PLANS OF PROPOSED IMPROVEMENT ON THE
PRIMARY ROAD SYSTEM
Black Hawk COUNTY
Bridge Replacement
Wapsie River Overflow
2.7 mi. W of Elk Run Road
Location
SCALES: As Noted

D2 PLAN - Date: 07-24-2026

D2 Questions for District 2 – with 7/22/2026 D2 Field Exam Responses in GREET TEXT. Responses include Post-D2 Follow-Up E-Mail Correspondence (dated 7/24/2026) between Road Design (Jonathan

Re: BRF-281-1(054)--38-07
Bahr) and District 2 (Ashton Johnson):
FYI, MEETING MINUTES from prior Design Meetings are referenced, but not included in the D2 Field Exam Markup set.

IA 281
Existing Pavement

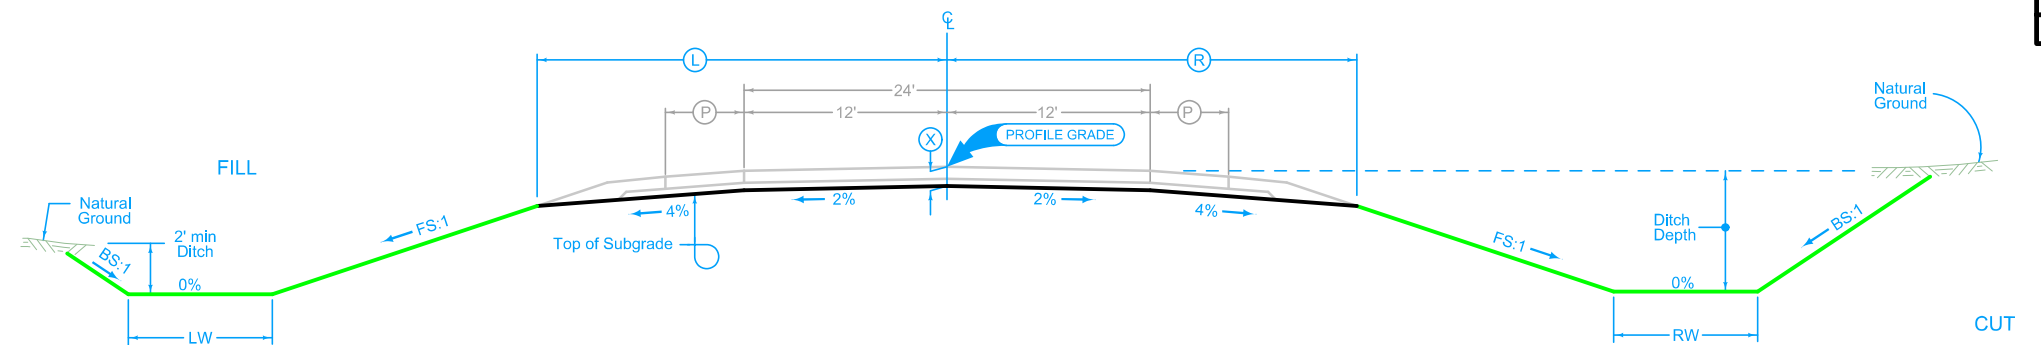
- c. 2026-07-22 Field Exam Response: John Bartholomew (Pre-Design) recommended that the Traveled Way AND Paved Shoulders beyond the Approaches should match the thickness of the Approaches (12”) for ease of construction purposes. This decision was justified by the fact that there is a relatively small amount of Roadway reconstruction beyond the Approaches. John Bartholomew said it was previously determined by the Design group that projects that only have around 150’ of proposed roadway beyond the Approaches should go ahead and have the Traveled Way and Paved Shoulders match the Approach thickness for ease of construction purposes. The Field Exam Team was OK with this decision.

- d. 2026-07-22 Field Exam Response: John Bartholomew asked Jonathan Bahr to reach out to Danny Zeimen (Pavement Design) to ask if the 12” Modified Subbase could be changed to 12” Granular Subbase. John Bartholomew said he thought the DOT is trying

to move away from the installation of Modified Subbase on projects where we’re not going to have Traffic driving on it for Construction Staging. John Bartholomew said that Danny Zeimen may still want the Modified Subbase beyond the Approaches because the Approaches already are specified to have Modified Subbase per the Standard Road Plans and the Roadway beyond the Approaches is such a small area that we may as well specify Modified Subbase everywhere.

- i. 2026-07-27 Field Exam Follow-Up Correspondence between Road Design (Jonathan Bahr) and Pavement Design (Danny Zeimen): Jonathan Bahr reached out to Danny Zeimen (Pavement Design) via e-mail with respect to whether the 12” Modified Subbase under the normal Roadway should be changed to 12”

RE_
BRF-281-1(054)--38-(
Granular Subbase.

IA 281
Bridge Approach Pavement

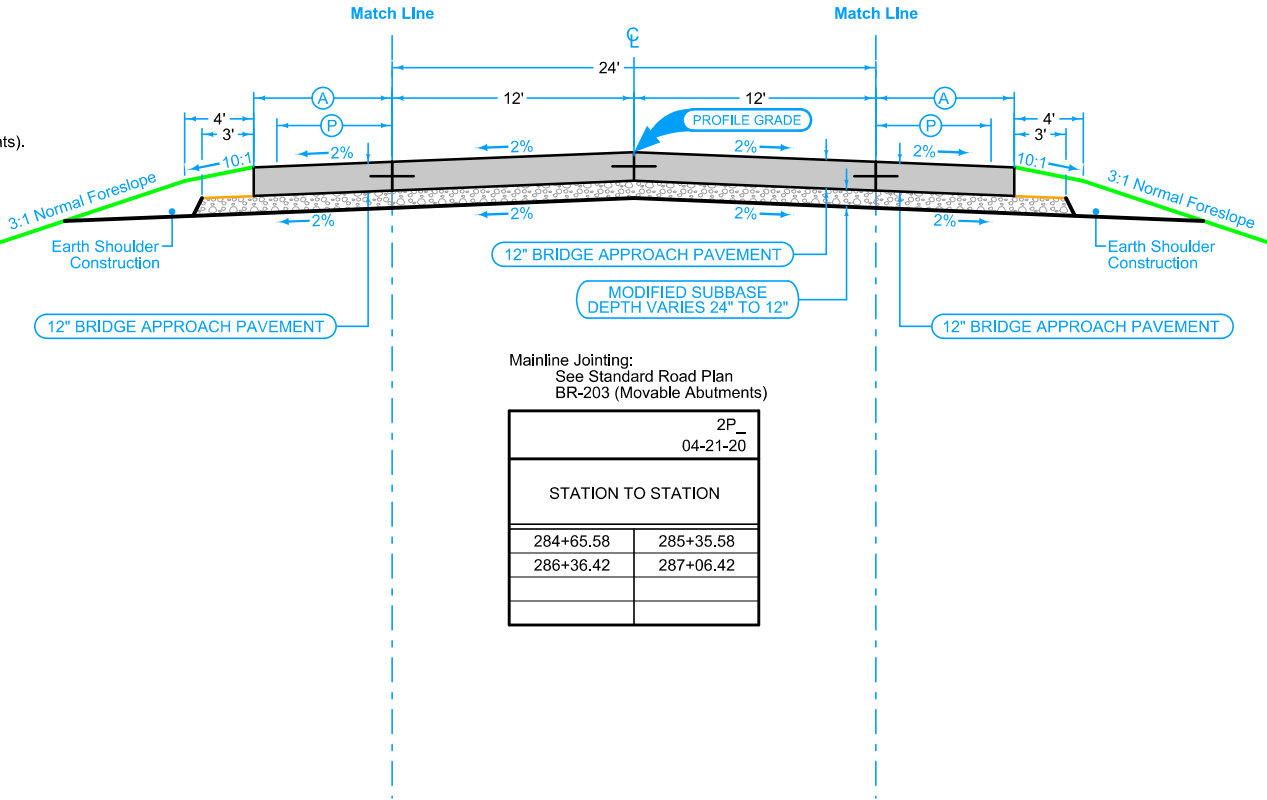
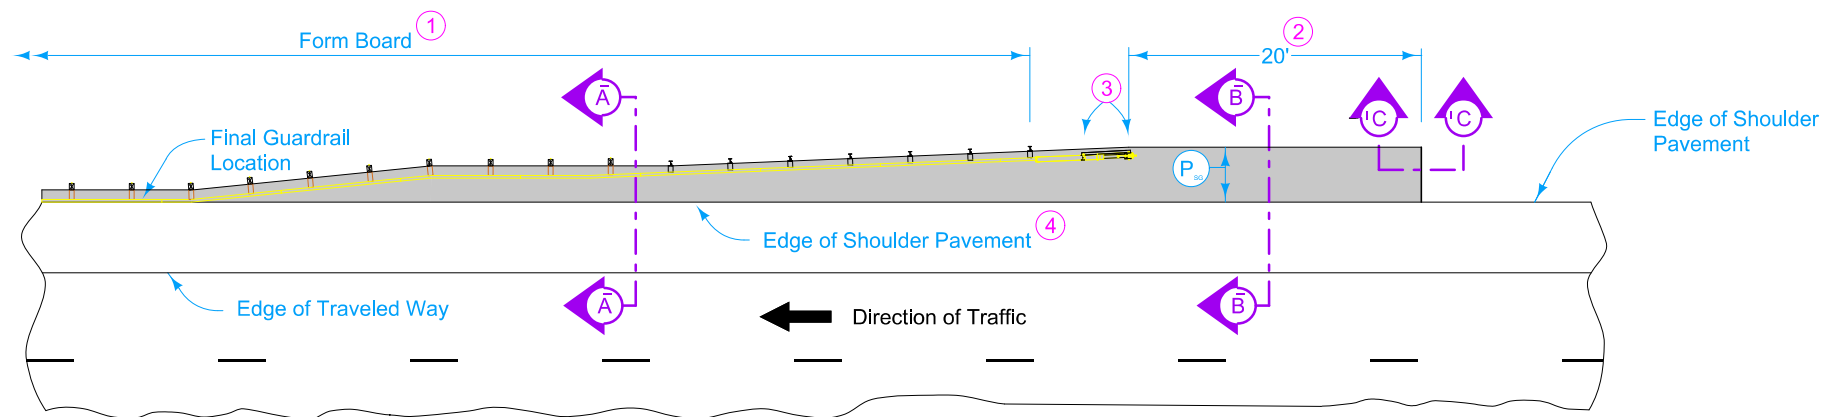
- a. According to Section 5.8.6.1.2 of the Bridge Design Manual: Double reinforced bridge approaches (BR-200s) are used for interstate and primary bridges. A 12-inch approach should be used for new construction.
 - i. 2026-07-22 Field Exam Response: No comments.
- b. It has not yet been determined whether the abutment is a ‘movable’ abutment or a ‘fixed’ abutment: The body of the Project Concept did not indicate whether the Bridge will have Stub/Fixed/Battered Abutments or Integral/Movable/Normal Abutments. The Project Concept did not include a Preliminary Bridge Drawings. The ‘Bridge Bureau Attachment for Concept Statement’ did not have any information regarding the proposed abutments. Please verify the abutment type so that the appropriate Bridge

Approach Pavement Standard Road Plan is selected. The Note on the Bridge Approach Typical Section on the B Sheets will be updated as needed.

- i. 2026-07-22 Field Exam Response: Bridge Bureau will provide information regarding the abutment type once it is determined.
- c. The double reinforced section will NOT be longer than 20' (as measured along the centerline of the road) because the proposed Bridge does NOT have a skew. The Designer Information for Bridge Approach Pavement section of the Standard Road Plans say "If the need arises for the double reinforced section to be longer than the 20 foot minimum shown on BR-201, BR-202, BR-203, and BR-204, contact the Bridges and Structures Bureau to verify location of the lug for movable abutments." FYI, if the Abutment for this Bridge is Fixed (not Movable), then the location of the lug for Movable Abutments in such circumstances (double reinforced section is longer than the 20 foot minimum) is not applicable.
